Access Compliance Report

Public Rights-of-Way

(Curb Ramps)

Intersection ID: 10584	Main Street: COXE_AV	Cross Street: S_TURNER_AV	Location:	N
ADA ID: FF4EB1006663	Ramp Type: Perp	Initial Pass/Fail: Fail	Overall Compliance: No	Severity Score: 13.75

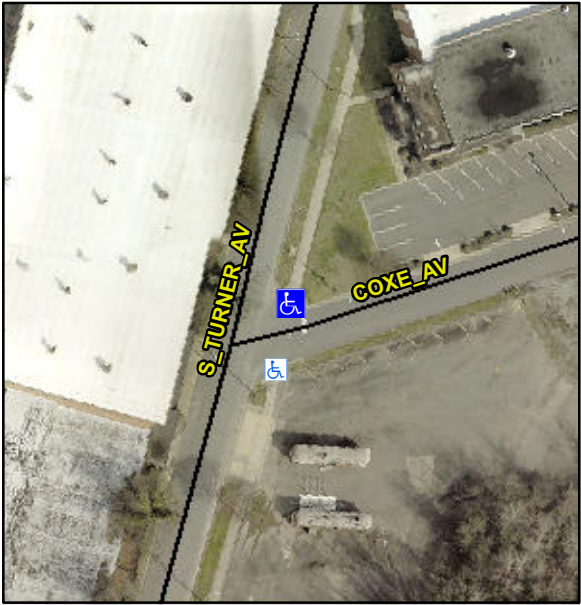
Codes/Mitigation Info/Possible Solution			Field Measurements/Component Compliance		
	Possible Solutions:		Compliance	Description	Data
	Remove & Replace Entire Ramp.		N/A	Ramp Length (in)	100.5
			Yes	Ramp Width (in)	64.0
			N/A	Flare Type LT	N/A
			N/A	Flare Slope LT (%)	N/A
			N/A	Flare Traversable LT?	N/A
			N/A	Landing Length (in)	N/A
			N/A	Landing Width (in)	N/A
			N/A	Landing Slope (%)	N/A
			N/A	Landing X Slope (%)	N/A
<p>Surveyor Notes:</p> <p>N/A</p> <p>PROW/ADA:</p> <p>Not Found, R304.2.2, R304.5.3</p>			N/A	Flare Type RT	N/A
			N/A	Flare Slope RT (%)	N/A
			N/A	Flare Traversable RT?	N/A
			N/A	DWS Provided?	N/A
			N/A	DWS Contrast?	N/A
			N/A	DWS Length (in)	N/A
			N/A	DWS Full Width?	N/A
			N/A	DWS Offset (in)	N/A
			N/A	Shared Landing?	N/A
			N/A	Gutter Ponding?	Yes
			N/A	Gutter Lip Ht (in)	N/A
			N/A	Painted X Walk1?	No
				X Walk 1 Direction	To SW
			N/A	X Walk 1 Width (in)	N/A
				X Walk 1 Slope (%)	0.8

X Walk 1 X Slope (%)	1.5
			N/A	Ramp inside XWalk1?	N/A
			N/A	Road Slope (%)	N/A
			N/A	Road X Slope (%)	N/A
			N/A	Any Obstructions?	N/A
				Obstruction Type	
Total Cost:		\$ 1850.00			
			N/A		N/A
			Yes	Surface Condition? (G/P)	Good
